**ADDENDUM NO. 1  
TO CONTRACT DOCUMENTS FOR THE  
UPPER LLAGAS CREEK FLOOD PROTECTION PROJECT, PHASE 1  
Project No. 26174052 Contract No. C0645**

ADDENDUM NO. 1

UPPER LLAGAS CREEK FLOOD PROTECTION  
PHASE 1: R4, PORTION R5, R7A, AND LAKE SILVEIRA PROJECT, C0645

ATTACHMENT 3  
Sheet PP-23

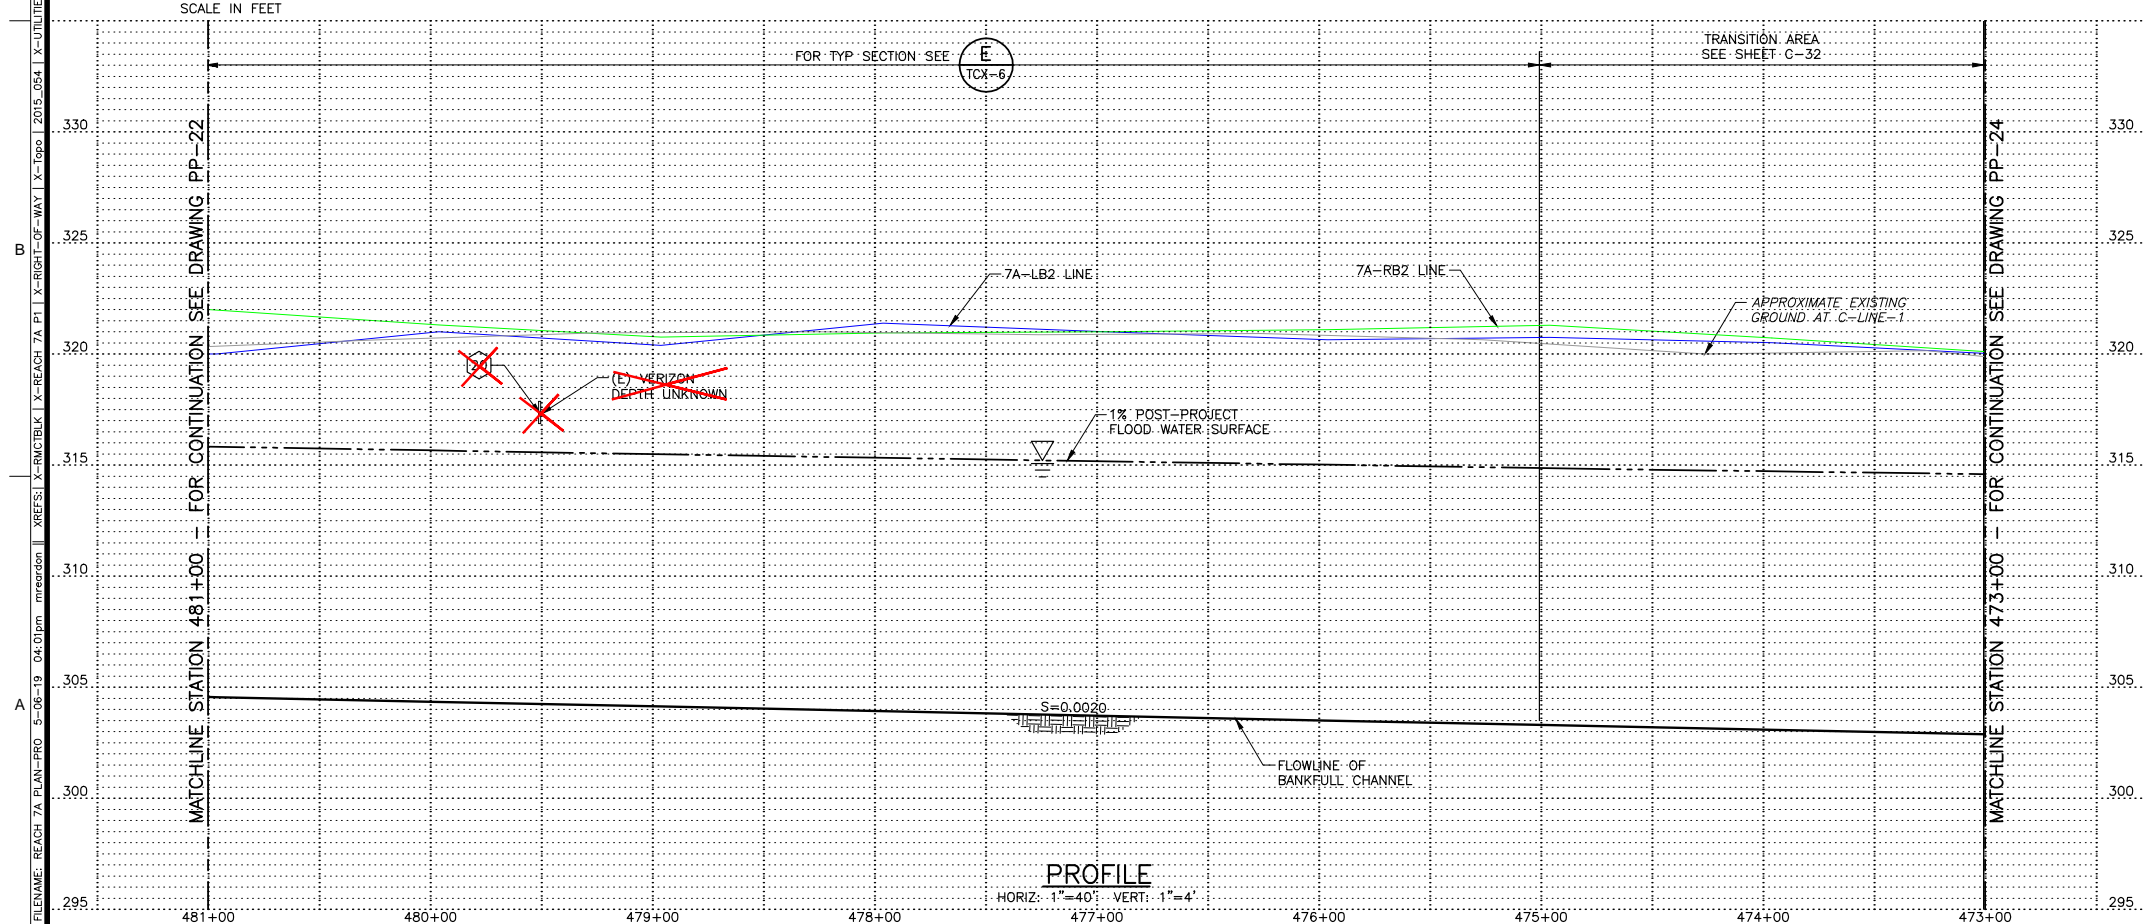
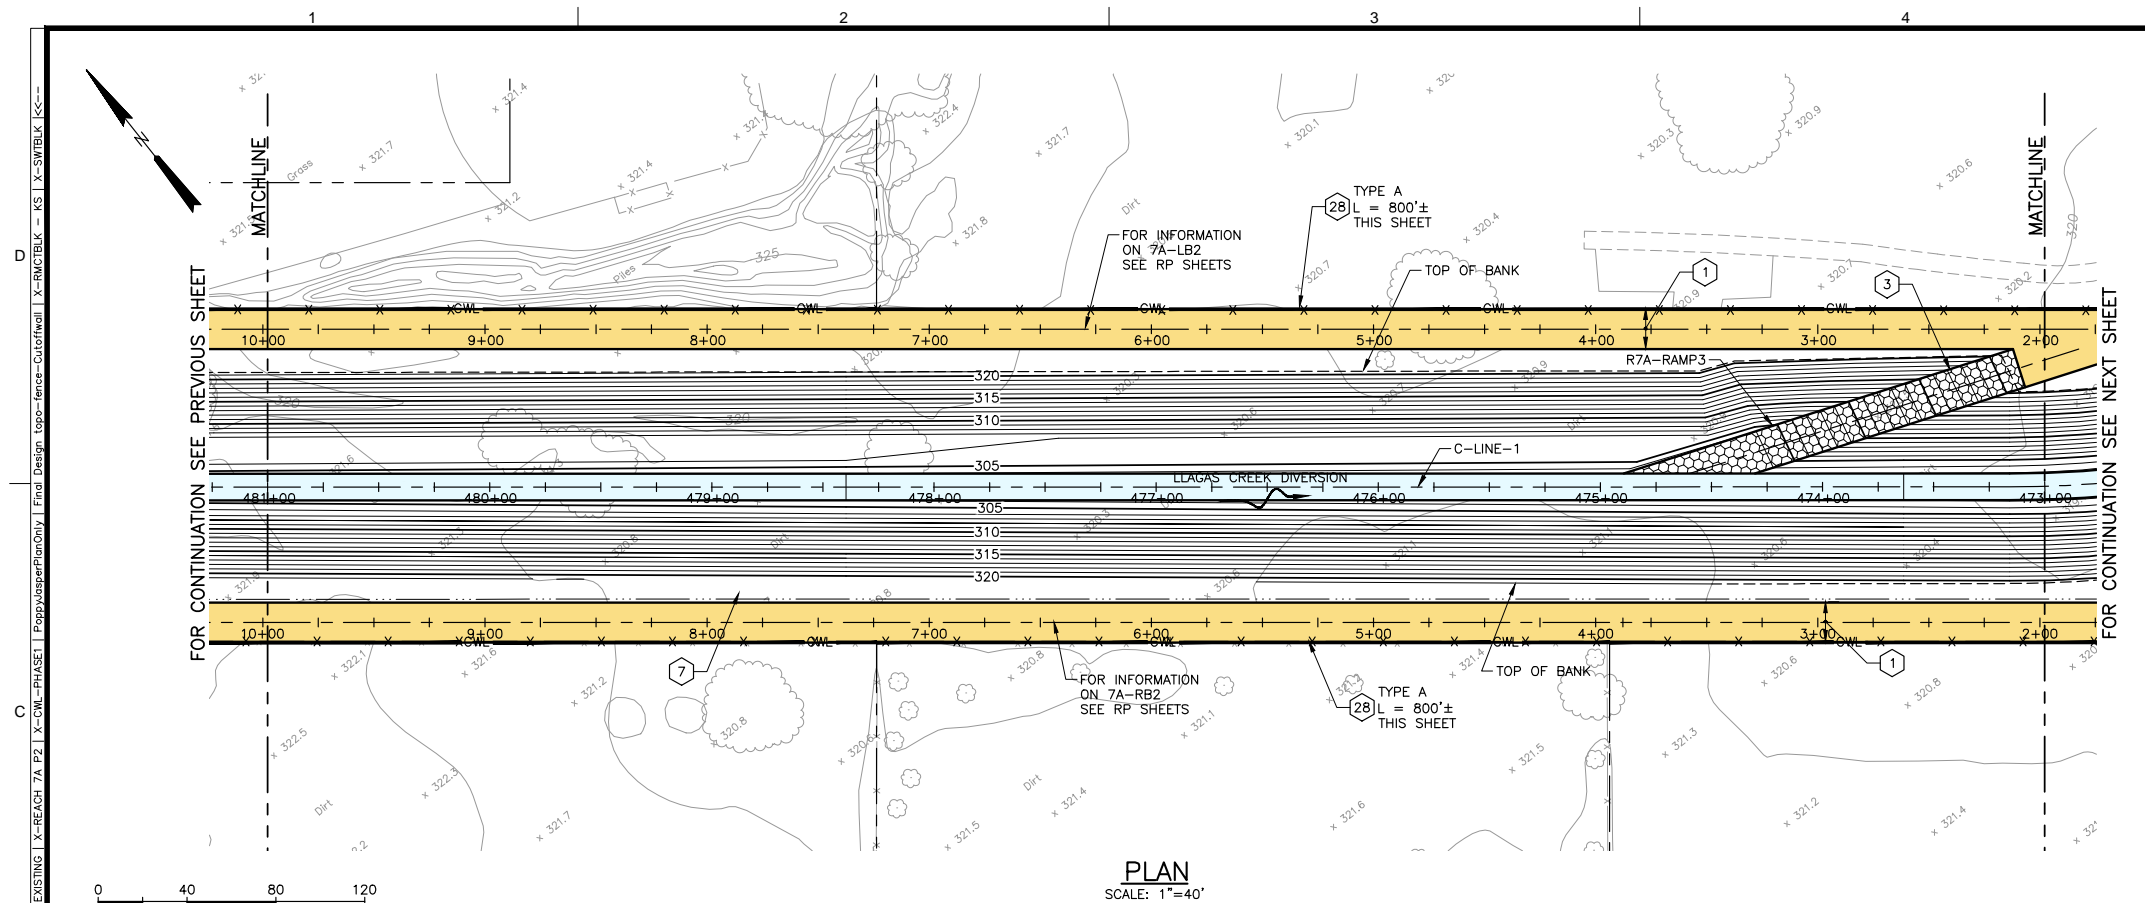
Attachment No. 1 – BID FORM NO.1 (Rev. 2)  
Attachment No. 2 – Sheet GC-10  
Attachment No. 3 – Sheet PP-23  
Attachment No. 4 – Sheet C-112  
Attachment No. 5 – Sheet GS-3
